**SUBJECT: REPORT OF CONFIRMATORY ACTIVITIES FOR THE QUIVIRA MINING COMPANY-AMBROSIA LAKE FACILITY WINDBLOWN TAILINGS DECOMMISSIONING PROGRAM, GRANTS, NEW MEXICO (DOCKET NO. 40-8905; RFTA NO. 99-041)**

**REPORT OF CONFIRMATORY ACTIVITIES FOR THE  
QUIVIRA MINING COMPANY-AMBROSIA LAKE FACILITY  
WINDBLOWN TAILINGS DECOMMISSIONING PROGRAM  
GRANTS, NEW MEXICO**

FIGURE 3: Quivira Mining Company – Background Exposure Rate Measurement and Sampling Locations

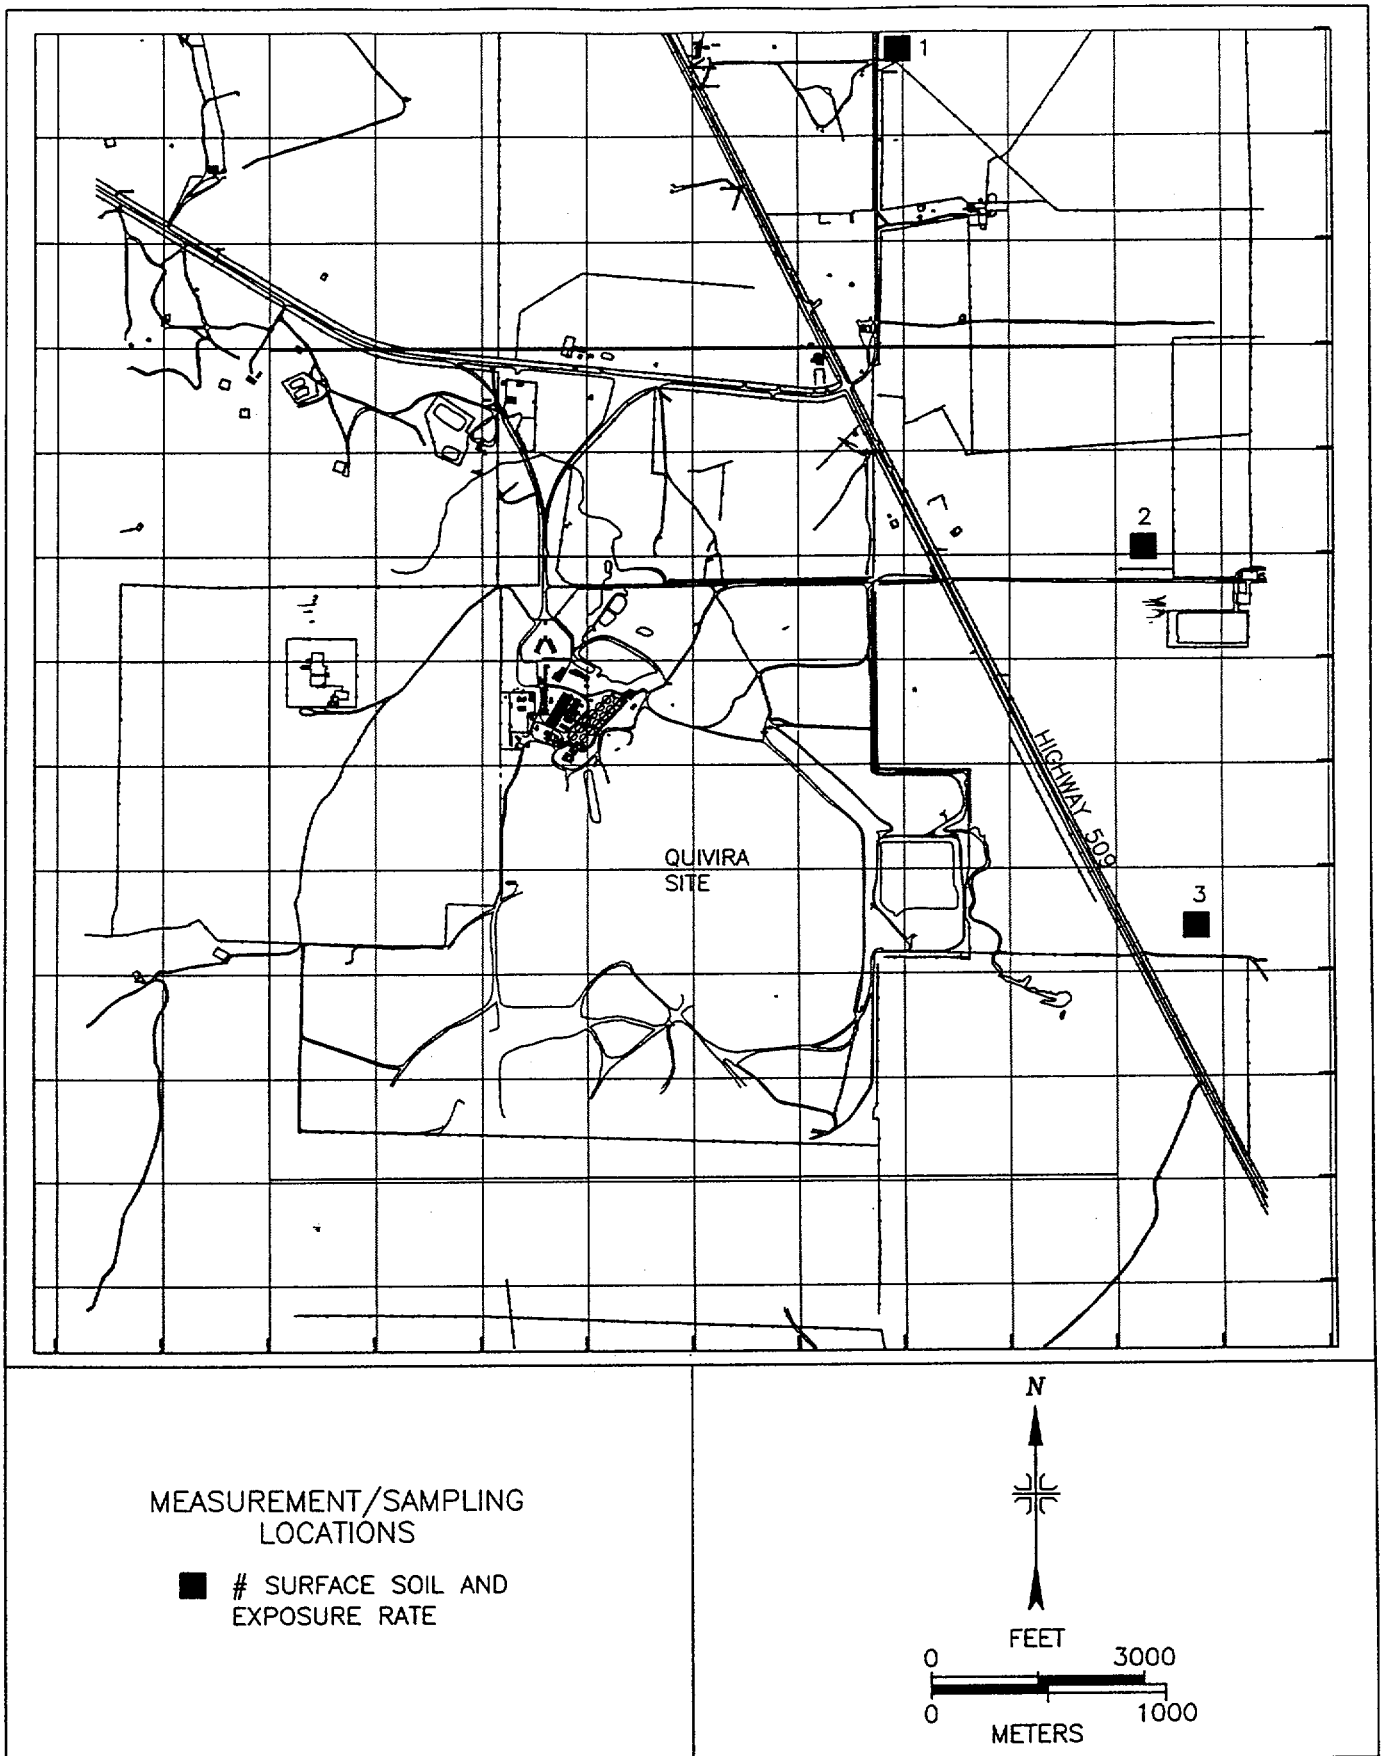
- The licensee provided an area topographical map showing 27 background sampling locations and the corresponding analytical result. Locations were evaluated for possible influence on the Ra-226 variability from nearby uranium mining operations or from ore haul roads. Several locations were identified as possible outliers. The licensee also indicated that several samples collected due south of the site came from an area that varied geologically from the windblown area and therefore may not have been representative. The licensee has been requested to reexamine the data and eliminate locations that are not representative of true background. In addition, samples were collected from three off-site locations for independent analysis (Figure 3). Results are provided in Table 1. These locations were intended as representative “background” locations. However, evaluation of the data identified a difference between the uranium concentrations and the concentrations of the uranium daughters, Ra-226 and Th-230. The potential therefore exists that the soil in this area has been influenced by contamination. In a natural background state, the concentrations between the three radionuclides would be expected to be relatively equal. The radionuclide concentrations in these samples ranged from 4.4 to 7.1 pCi/g for Ra-226, 5.8 to 10.0 pCi/g for Th-230 and 1.7 to 2.5 pCi/g for U-238.

FIGURE 4: Quivira Mining Company – Surveyed Areas

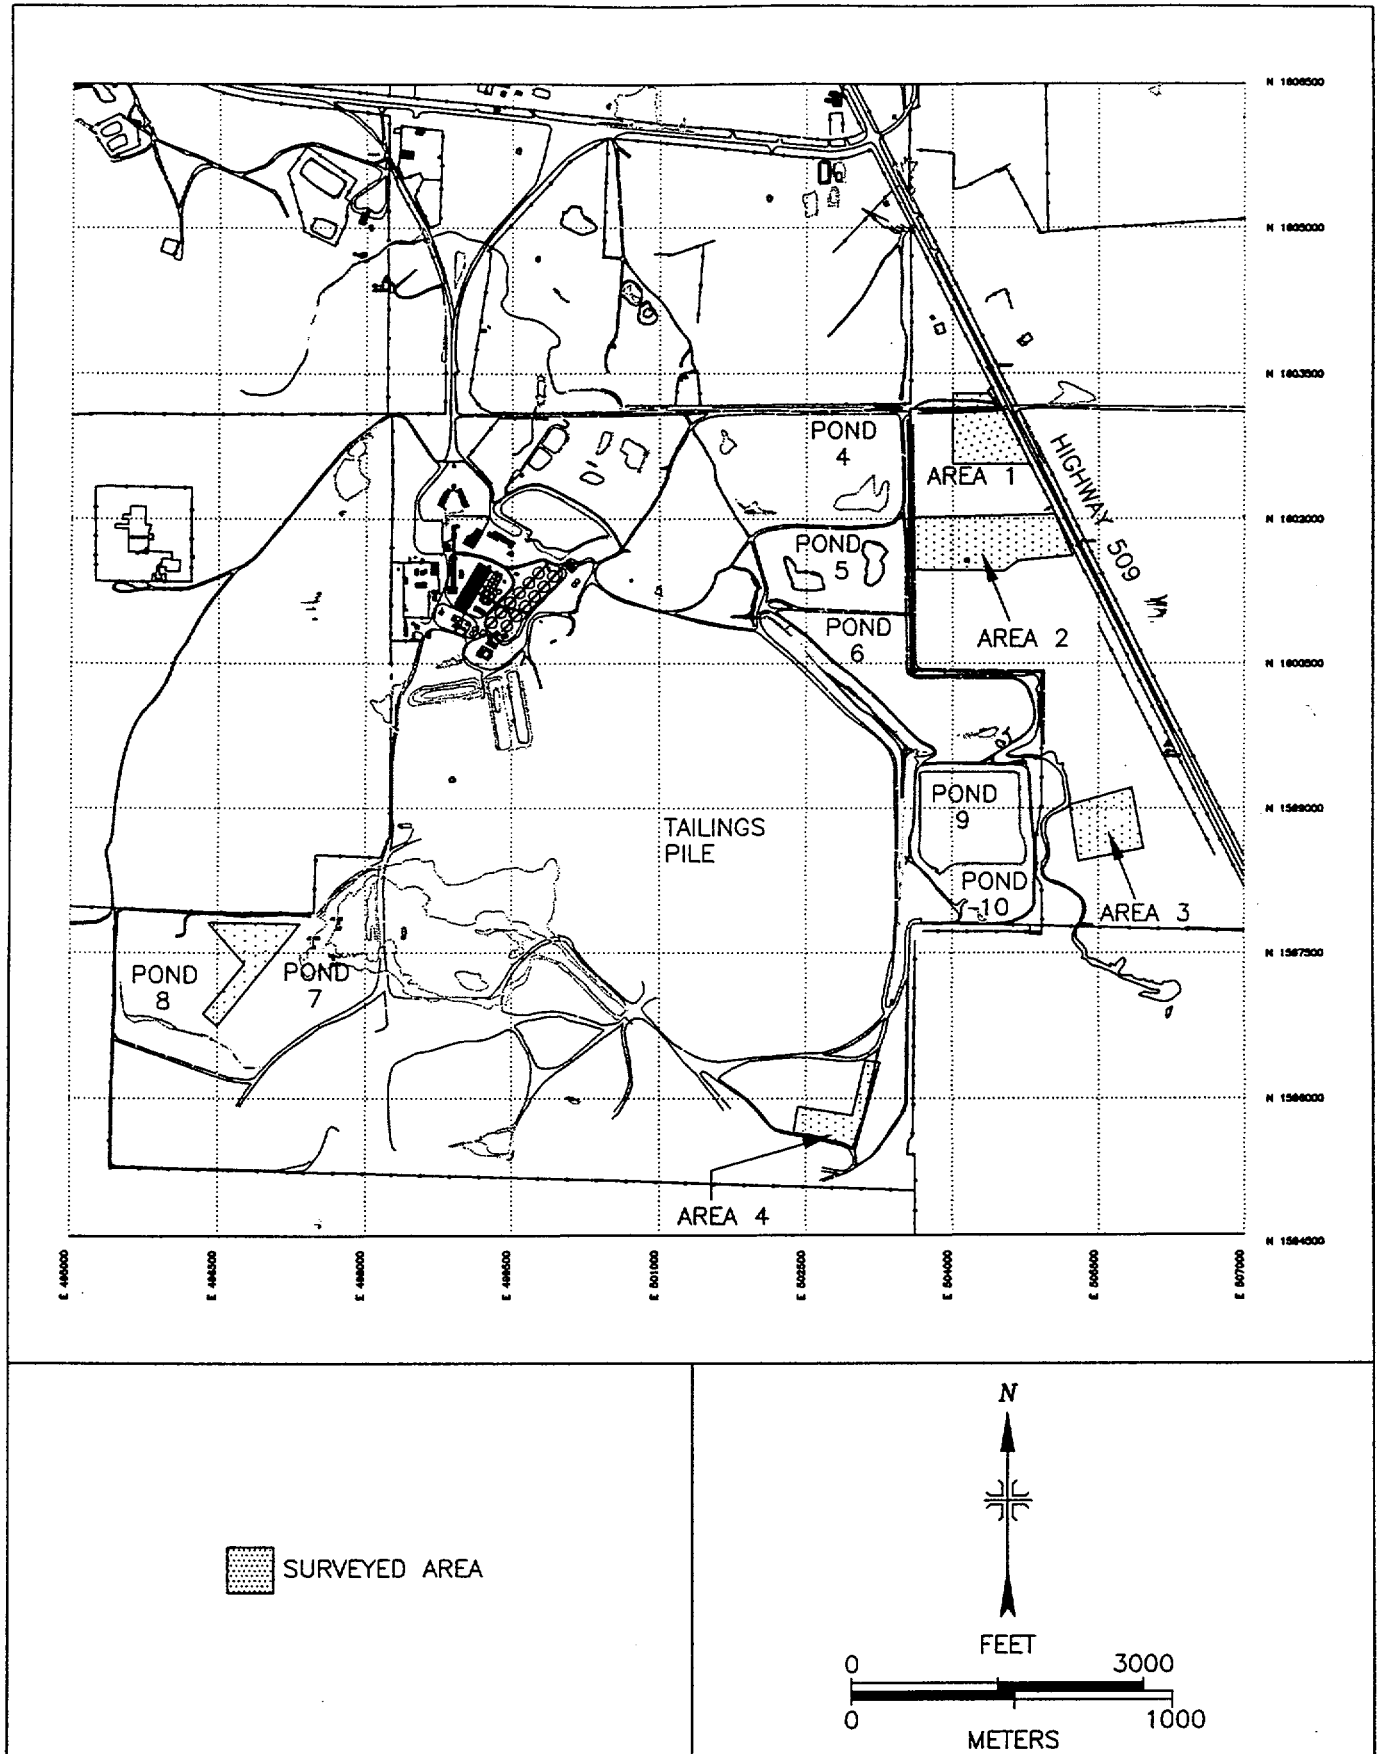
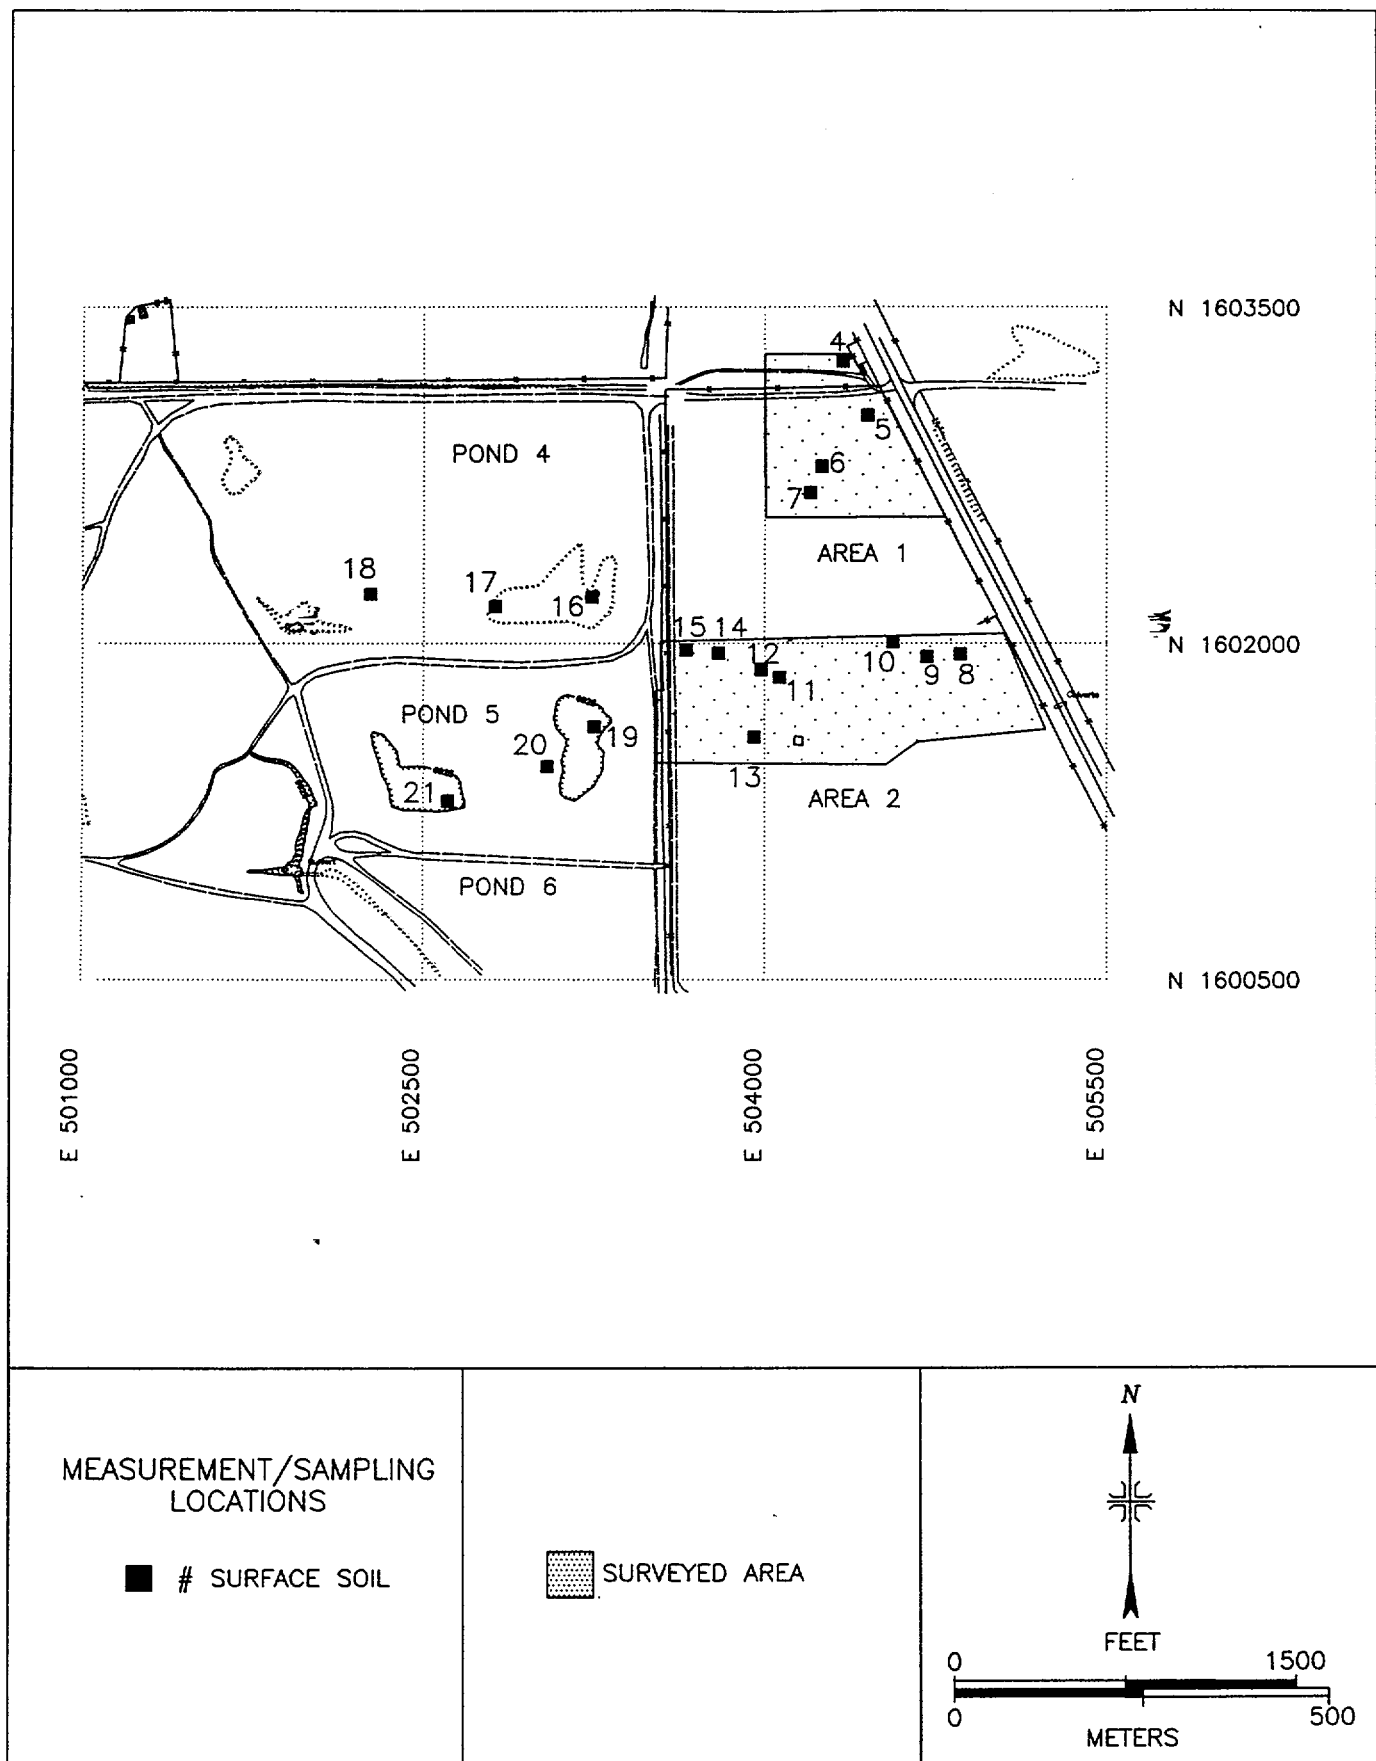
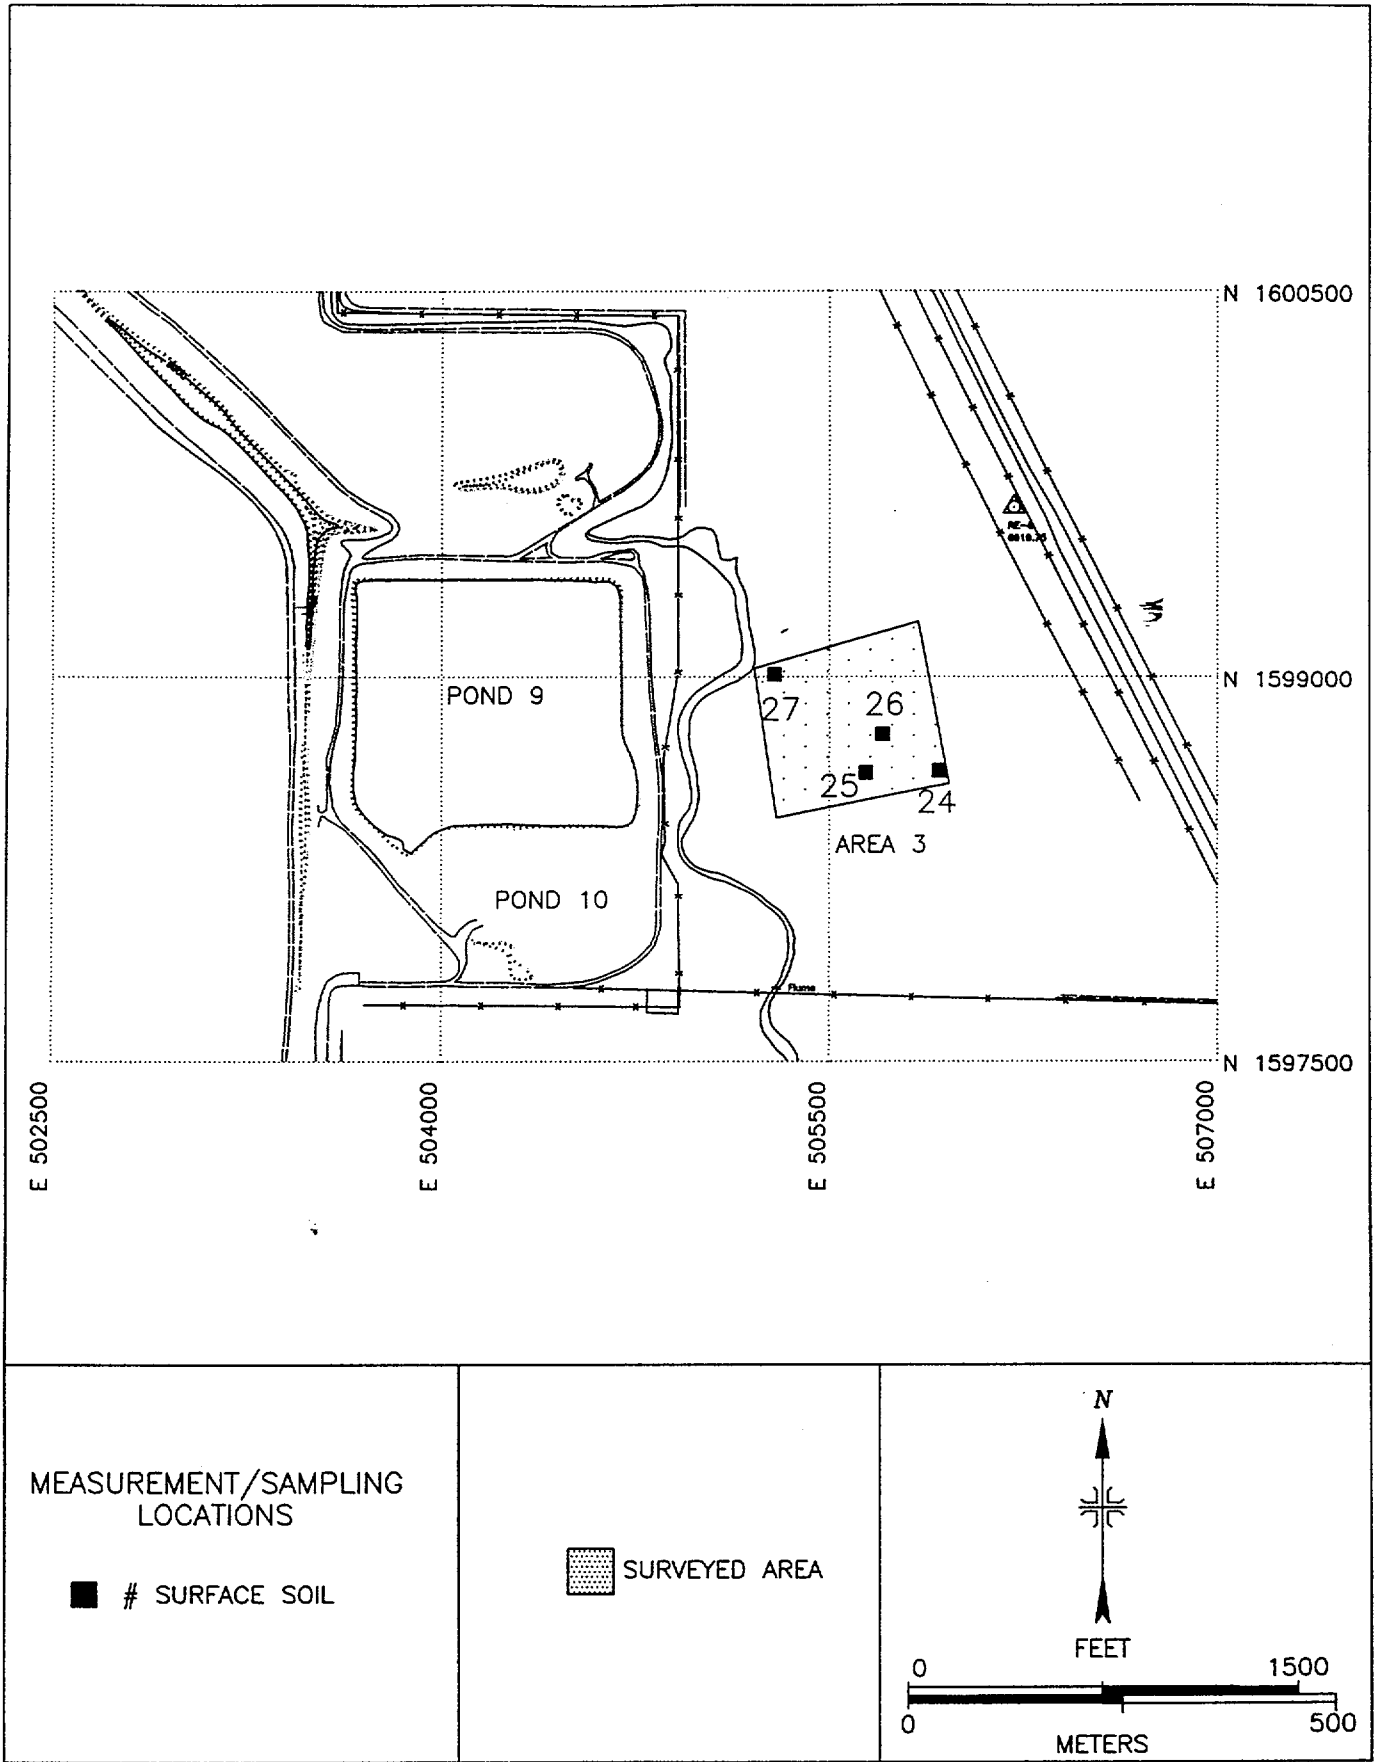
- Confirmatory gamma surveys were performed over four windblown tailings areas. Surveyed areas are shown on Figures 4 through 7. Surveys of these areas consisted of gamma surface scans using NaI scintillation detectors coupled to ratemeters with audible indicators. The distance between the detector and the ground surface was maintained at a minimum—nominally about 10 centimeters. Within each area surveyed, parallel one meter-wide detector scan paths were traversed for the entire length of the area. Scan paths were walked at intervals of every 10 to 20 meters across each surveyed area. Areas of elevated direct radiation in excess of the ambient background by a factor of greater than two times were marked and 100 % of the surrounding area was scanned. There were numerous such areas identified while performing the gamma scans. Sixteen representative anomalous areas identified were then selected for soil sampling. Samples were collected from the center of each selected anomaly and from four points equidistance between the center and what would be the corners of a 10 m × 10 m area, and field composited. Within Ponds 4, 5, and 8, general area gamma measurements were made while traversing each pond from end-to-end. General elevated gamma activity up to 10 times ambient background was noted throughout each of the ponds. Composite soil samples as described above were collected from three locations each in Ponds 4 and 5. For Pond 8 which had been remediated and backfilled, a composite sample was collected from one location at the surface (0 to 15 cm) and then a composite subsurface (15 to 30 cm) sample collected. Figures 5 through 7 show soil sampling locations. Exposure rate measurements were determined not to be required with the NRC representative's concurrence.
